Differing Professional Opinion – Diablo Canyon Seismic Issues

Figure 1, Comparison of the DDE/SSE and the HE Floor Response Spectrum, Containment Elevation 88'

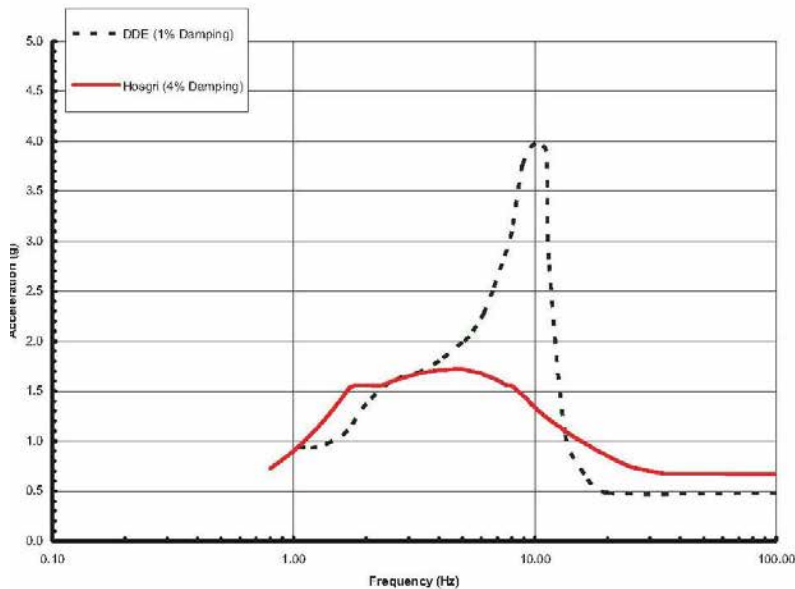
Figure 1 illustrates the results of the different methods and assumptions use in DDE/SSE safety analysis and the HE. This figure compares acceleration levels (shaking) in the reactor containment building.

Plant SSCs are most affected in the 3 to 8.5 Hz frequency range.

Note that the level of "shaking" is significantly greater for the SSE/DDE than for the HE at this plant location. This may seem counterintuitive since the HE is a much larger earthquake. However, as this figure illustrates, comparing ground motion alone is not sufficient to evaluate seismic qualification. Methods, assumptions, initial conditions, and acceptance criteria used in the analyses are just as important as ground motion.

The qualification process used information, such as shown in Figure 1, to establish the amount of seismic stress SSCs may be exposed to during the SSE. A component located at this location would be qualified for the SSE/DDE. If the SSC was also credited for HE safe shutdown, no additional qualification would be required. At this plant location, the seismic stress is dominated by the SSE/DDE. Qualification to the SSE/DDE would envelope the seismic stress generated by the HE.

Figure 2
 HE Maximum CRDM Bending Moments¹⁷

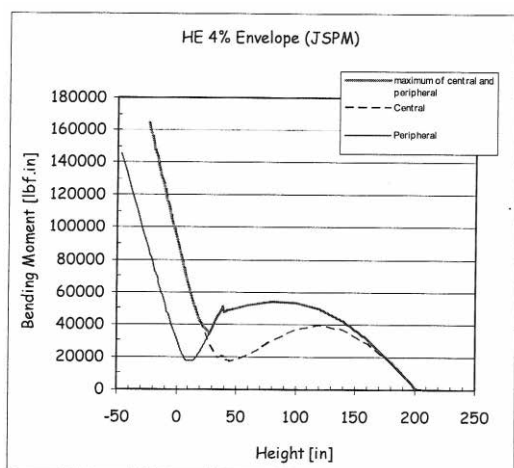
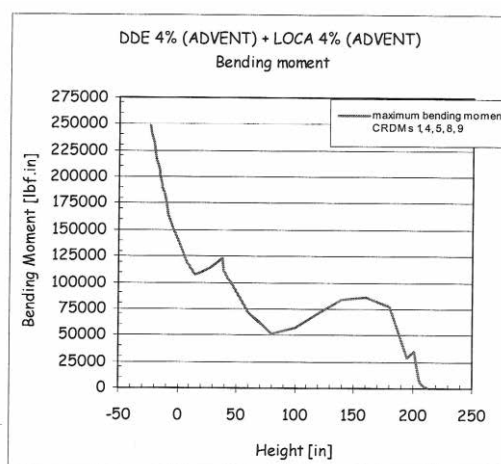
The Code methodology adds seismic loading, generated by either the SSE/DDE safety analysis or the HE, to other non-seismic loads affecting the component. The resulting SSE/DDE stress is significantly greater than for the HE in many loading cases. Again, this may sound counterintuitive since the HE is based on a much larger earthquake. These differences in component stress reflect the differences in the methods, assumptions, load combinations, and initial conditions used in each seismic analysis. For example, Figures 2 and 3 compare the Code bending moments calculated for the control rod drive mechanisms used to support the replacement reactor head modification. As seen in these figures, the bending moments (seismic stress) were much greater for SSE/DDE case than for the HE.

Figure 4
Comparison of the DDE/SSE and the HE Floor
Response Spectrum, Containment Elevation 88'

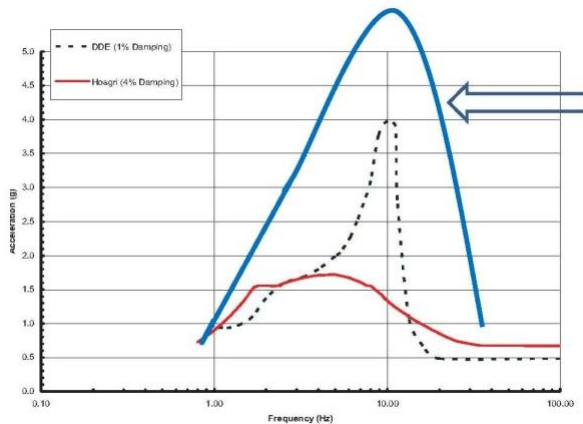
A comparison of the new seismic information against the existing SSE/DDE safety analysis would yield seismic stress greater than the values used during the original SSC qualification. However, in many cases, the actual SSC qualification tests were performed at higher levels than required to meet the design basis. These higher qualification levels provide engineering margin that may be recovered for “operability.”

Figure 5
Relationship between Acceleration, Velocity as a Function of Damping⁵⁷

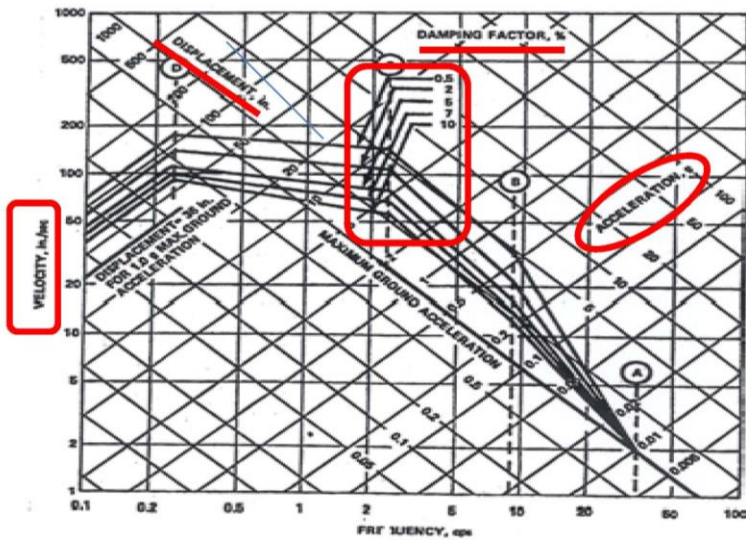
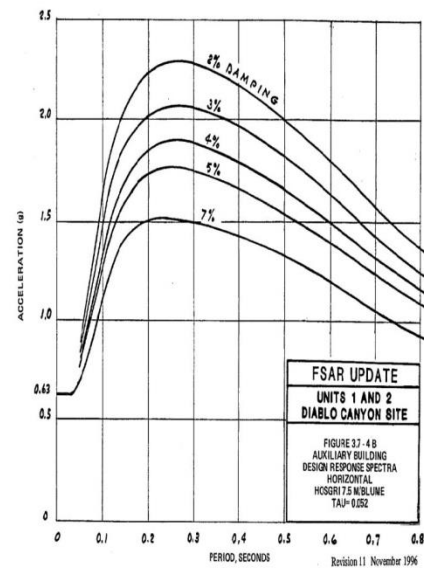
Higher damping values may be used for “operability,” provided that these values are appropriate to the application, as defined in the CLB. For example, the damping values specified for the SSE in Regulatory Guide 1.61, “Damping Values for Seismic Design of Nuclear Power Plants,⁵⁸” may be used. Also, damping values higher than presented in Regulatory Guide 1.61, may also be used provided that they have been NRC approved for the specific application and material.
